McFarlane Aviation Products

Service Bulletin SB-6 Rev. A

August 13, 2014

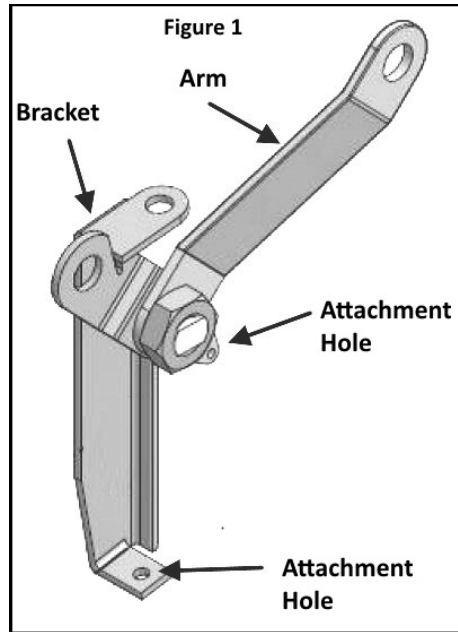
McFarlane Aviation has scrapped the existing part numbers and completely redesigned a new spring. The new spring is designated part number 6822 and will replace either part numbers 6748 or 6818. P/N 6822 features a larger wire size (~0.04"), a larger coil O.D. (~0.44"), and will be either zinc plated or coated with a black preservative. The new spring is visibly distinct from its predecessors.

Compliance is mandatory and requires immediate removal of P/N 6748 or 6818 springs and replacement with McFarlane Part Number 6822 spring. McFarlane Aviation, Inc. has determined that this operation falls under the category of routine maintenance and non-complex operation and thus the repair may be made by the aircraft owner, operator, or mechanic.

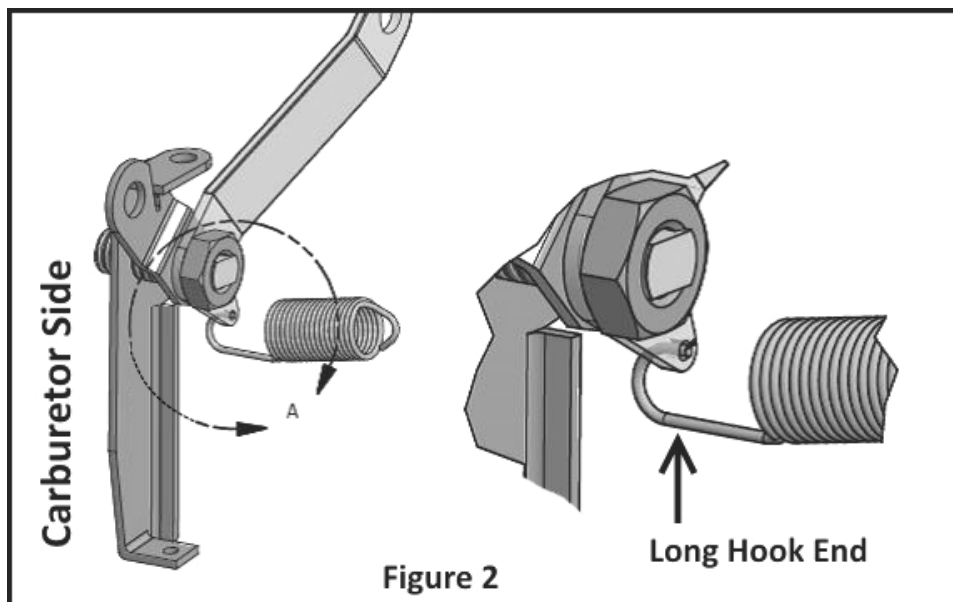
3. Install the new spring.
  - a. The long hook end of the spring is attached to the throttle linkage arm and must be oriented such that the hook end is facing away from the carburetor (Figure 2).

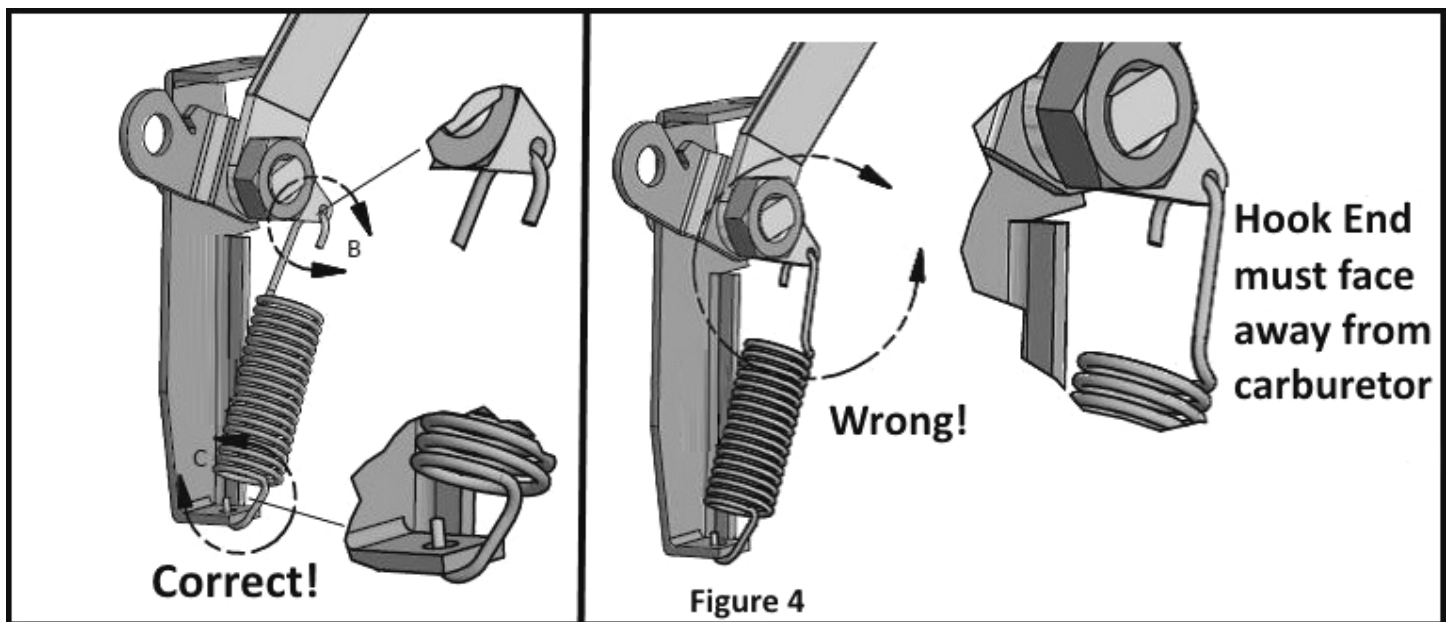
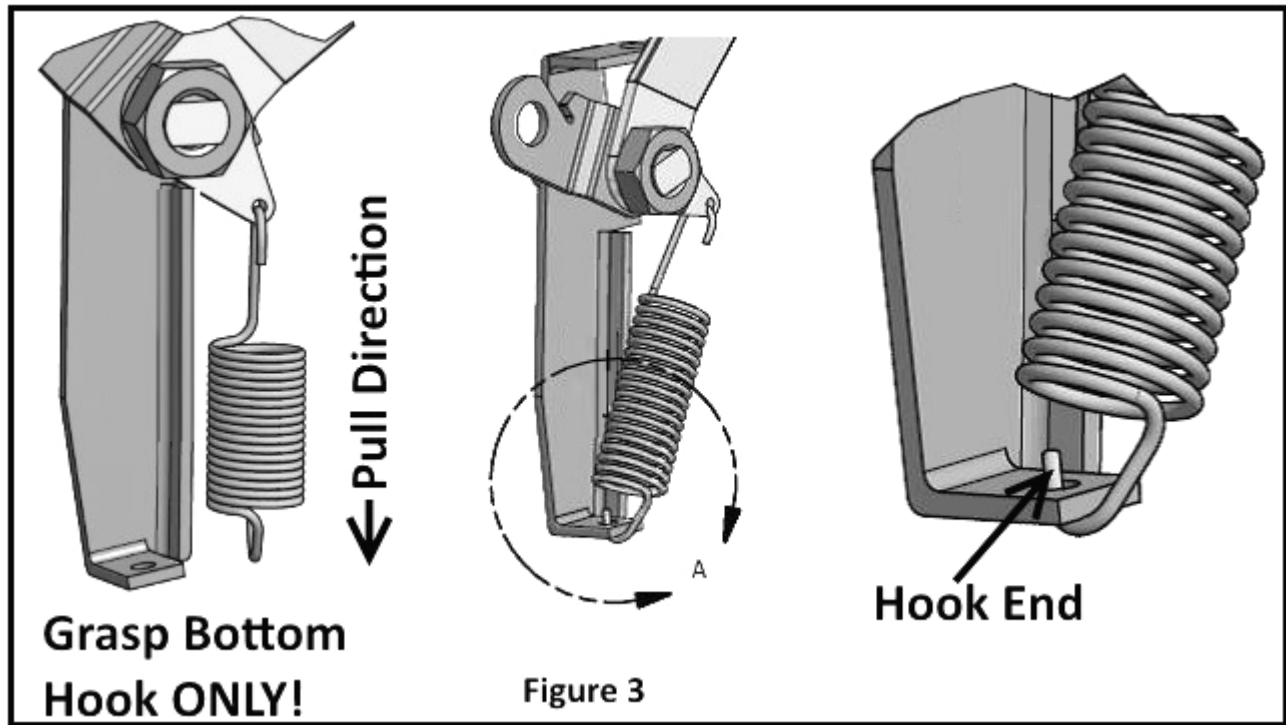
- b. Using only your hand, grasp ONLY the bottom hook and attach it to the fixed linkage. The hook end should be facing toward the carburetor body as shown in Figure 3. DO NOT TWIST the bottom hook during installation; doing so may severely limit the longevity of the spring. Correct installation position is shown in Figure 4.
